To: Planning Commission
From: Planning Division
Date: May 13, 2015
Re: **Rezoning: 2634 Lakeside Drive - B-3, Community Business District to B-5C, General Business District (Conditional)**

The purpose of the petition is to rezone the property from B-3, Community Business District to B-5C, General Business District (Conditional) to allow automobile sales, leasing and service. Outparcels not associated with the automobile dealership would be limited to uses allowed in the B-3, Community Business District such as restaurant, retail sales or office.

JOB:
**REZONING PLAN
 FOR 2634 LAKESIDE DR**

REZONING PLAN

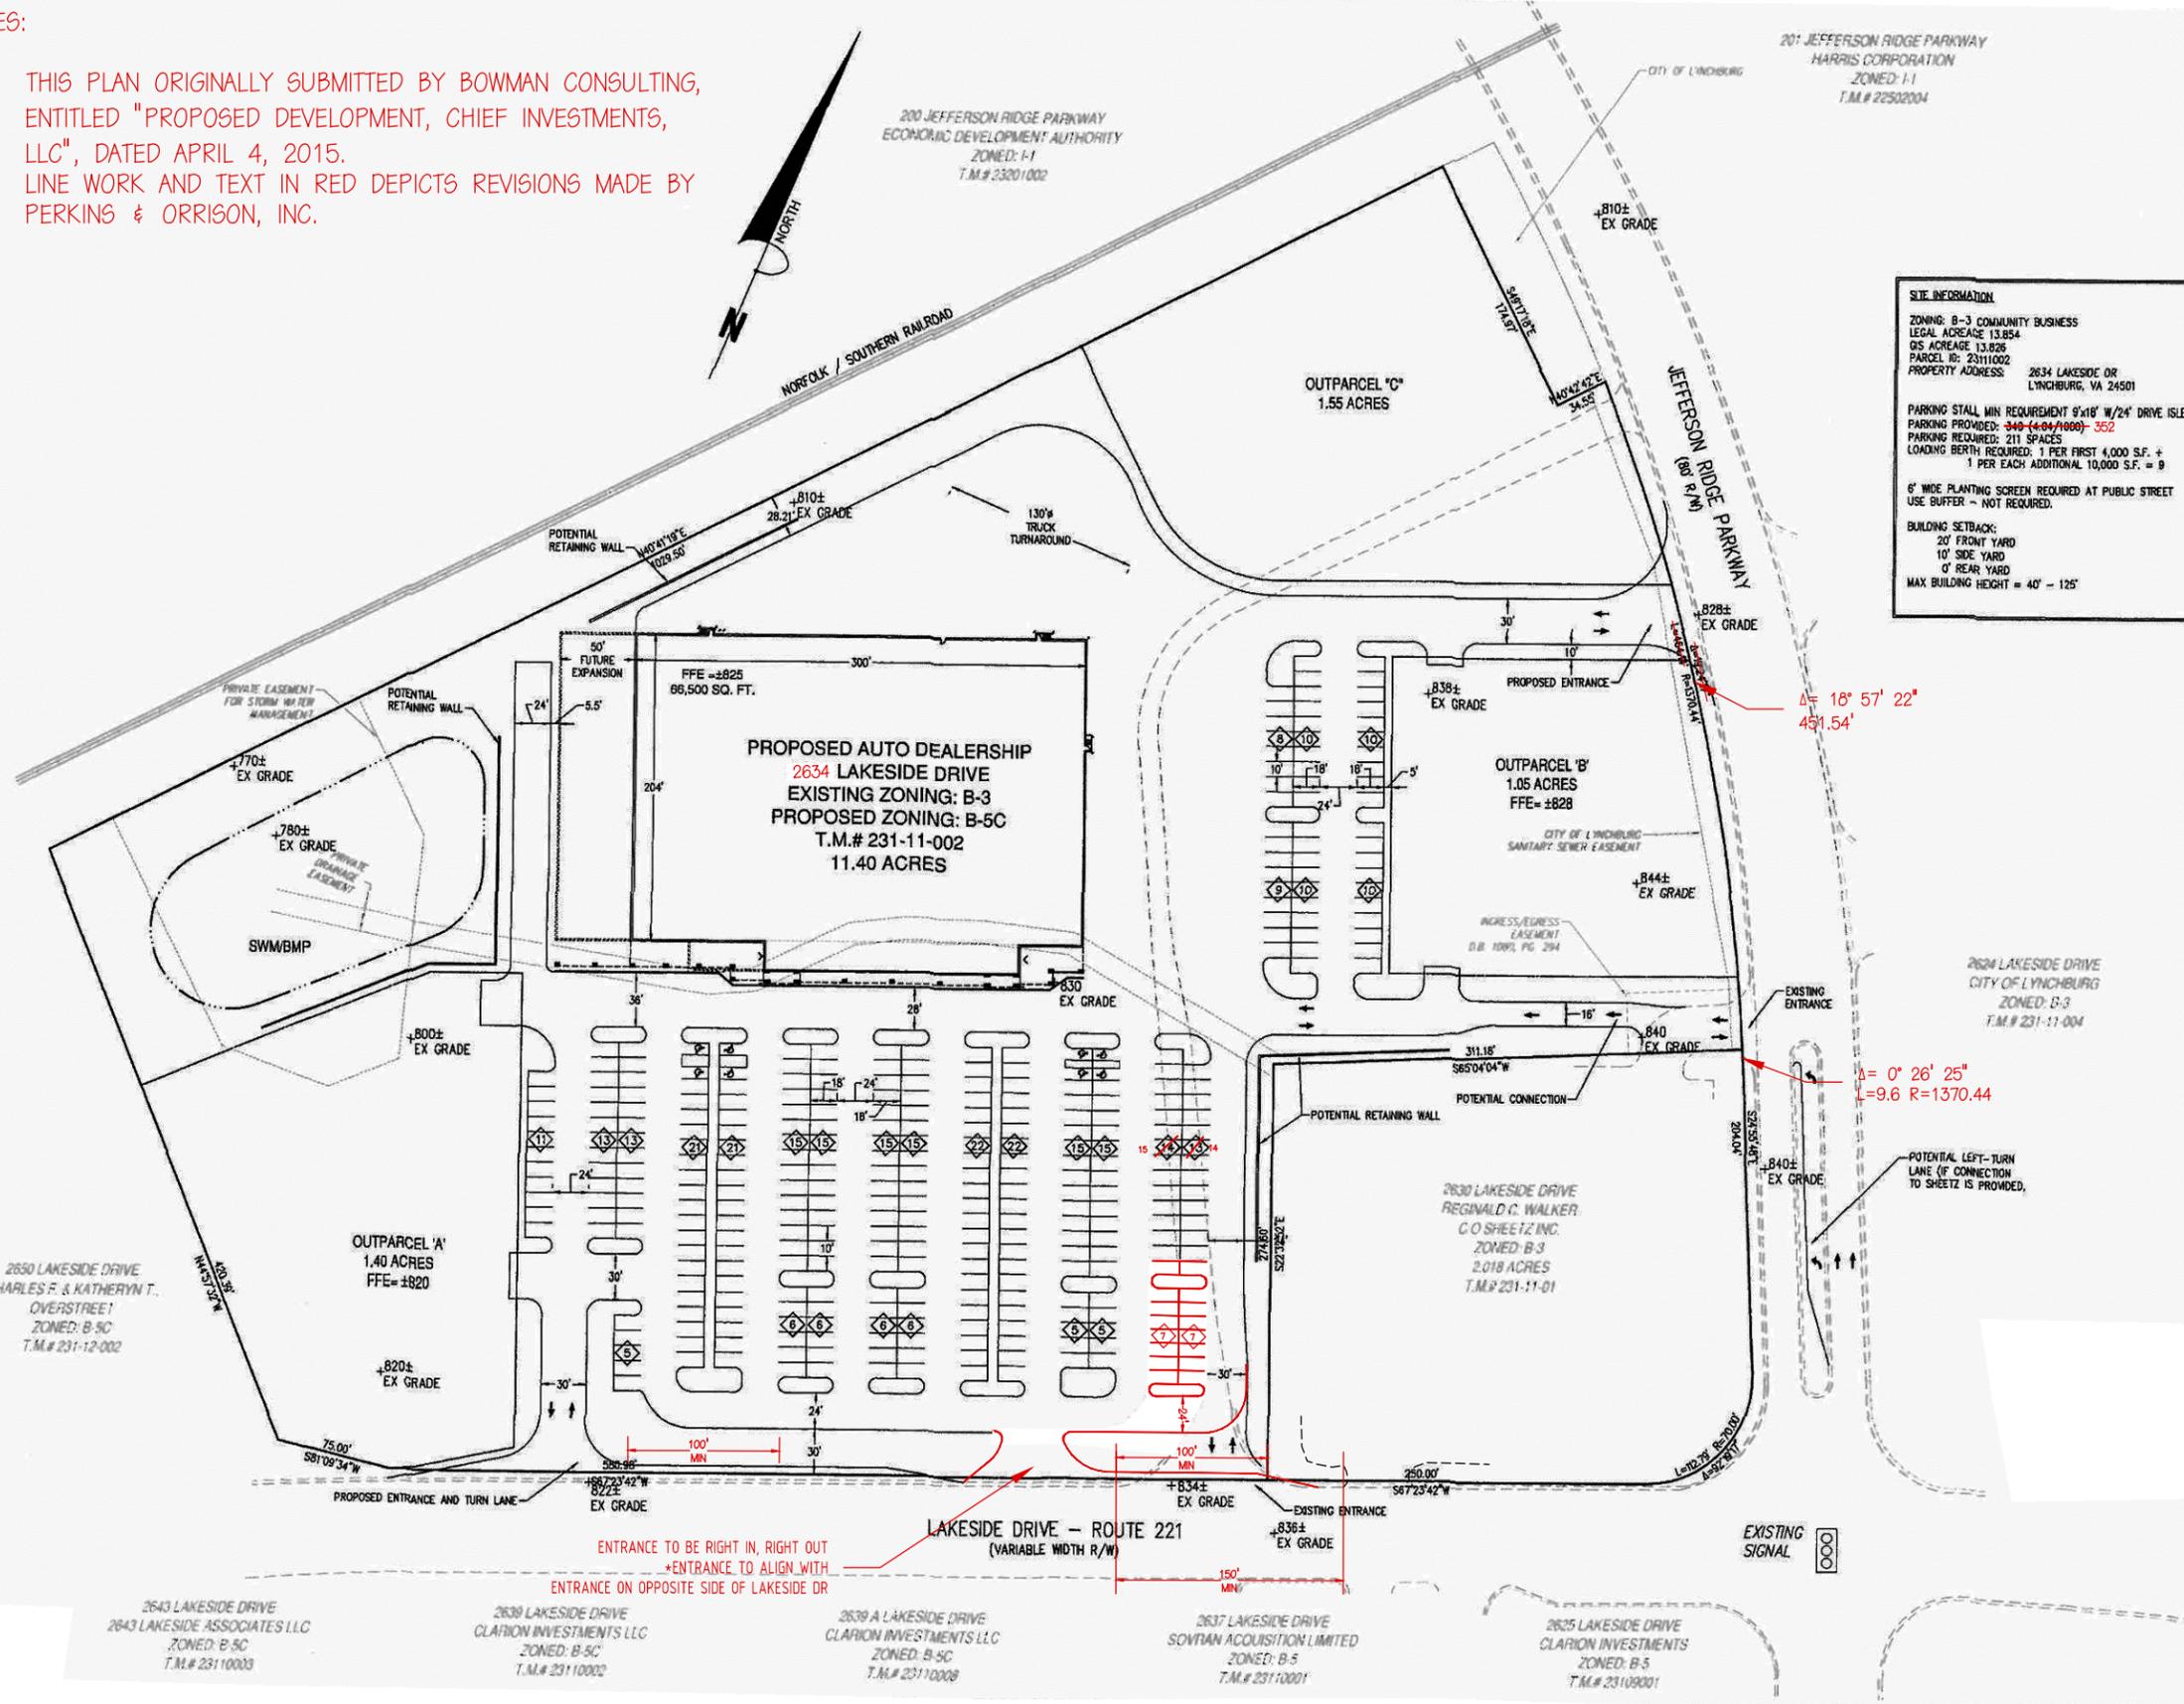
While the petitioner has proffered that “any sales of outparcels will have a provision in the deed requiring cross access and pedestrian connections”, the petitioner has chosen to not proffer the site plan. Staff is concerned that future development of outparcel “A” may request additional access onto Lakeside Drive. The Planning Commission may wish to consider seeking further clarification that an additional entrance will not be sought onto Lakeside Drive.

The submitted site plan also indicates a potential left turn lane into a shared connection with Sheetz. As indicated on the site plan, the turn lane as drawn would essentially eliminate the landscaped median on Jefferson Ridge Parkway and the entrance into the Lynchpin Industrial Park. Economic and Community Development staff would not support the destruction of this median. If a left turn lane is warranted it should be accomplished by lane striping or a widening of Jefferson Ridge Parkway to the north. Economic Development is currently developing plans to construct sidewalks in and new signage for the industrial park. The petitioner should work with Economic Development staff to coordinate need improvements on Jefferson Ridge Parkway.

Figure 12

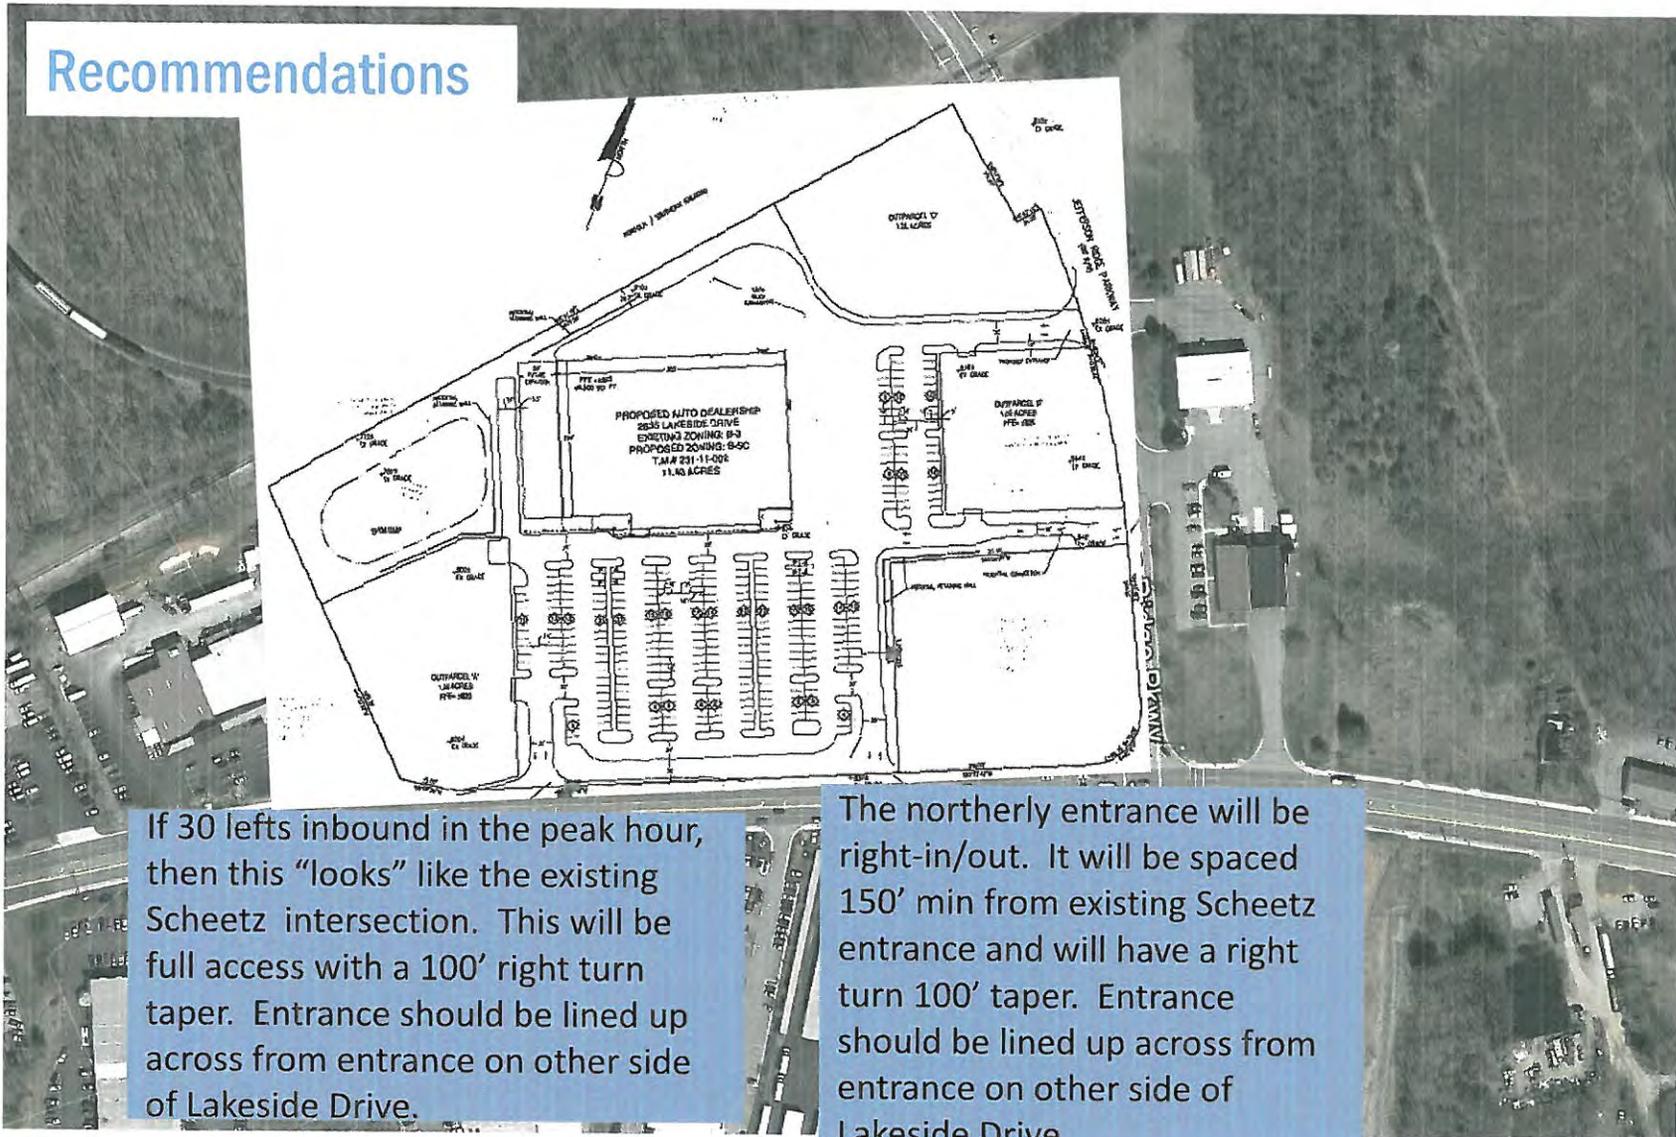
If 30 lefts inbound in the peak hour, then this “looks” like the existing Scheetz intersection. This will be full access with a 100’ right turn taper. Entrance should be lined up across from entrance on other side of Lakeside Drive.

The northerly entrance will be right-in/out. It will be spaced 150’ min from existing Scheetz entrance and will have a right turn 100’ taper. Entrance should be lined up across from entrance on other side of Lakeside Drive.
